DEPARTMENT OF ENVIRONMENTAL QUALITY
AIR QUALITY DIVISION
ACTIVITY REPORT: Scheduled Inspection

FACILITY: Speedway LLC - Mattawan		SRN / ID: P0372
LOCATION: 24118 COLE AVENUE, MATTAWAN		DISTRICT: Kalamazoo
CITY: MATTAWAN		COUNTY: VAN BUREN
CONTACT: Roy Hoin , Consultant		ACTIVITY DATE: 10/30/2013
STAFF: Dorothy Bohn	COMPLIANCE STATUS: Compliance	SOURCE CLASS: B
SUBJECT: targeted inspection of a remediation under a general PTI.		
RESOLVED COMPLAINTS:

Image 1(NW View) : Picture of the trailer looking towards the NW. The PVC pipe (on left) is for the air strippers. The metal stack (on the right) is for the SVE system. Taken on 10/30 by DB.

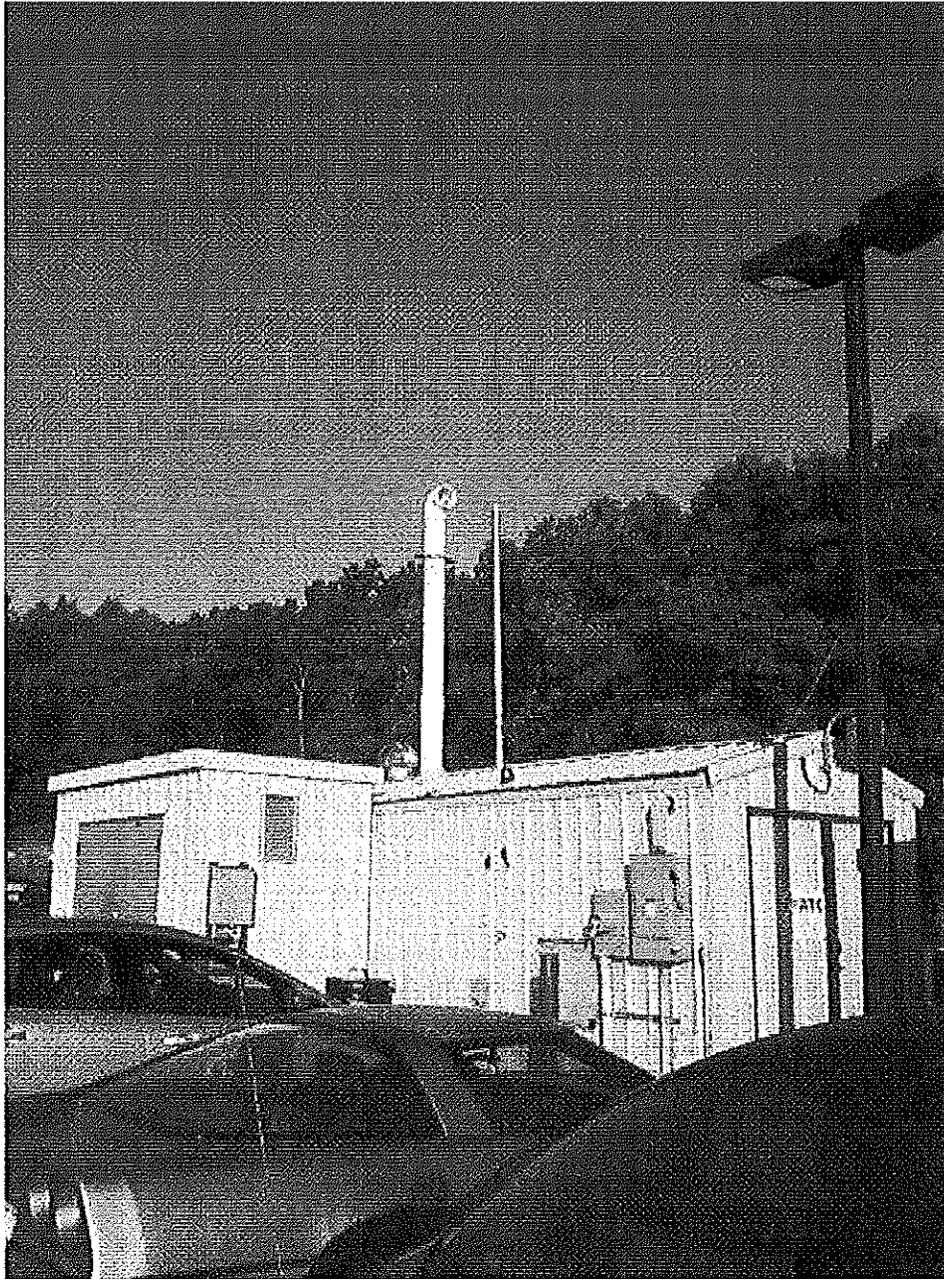
It looks like for the period of time that the air stripper operated under the PTI it was in violation of the stack requirements since it did not discharge unobstructed vertically upwards. Since this part of the process is not being used anymore I will send an email to Roy that if they should restart it they need to correct this.
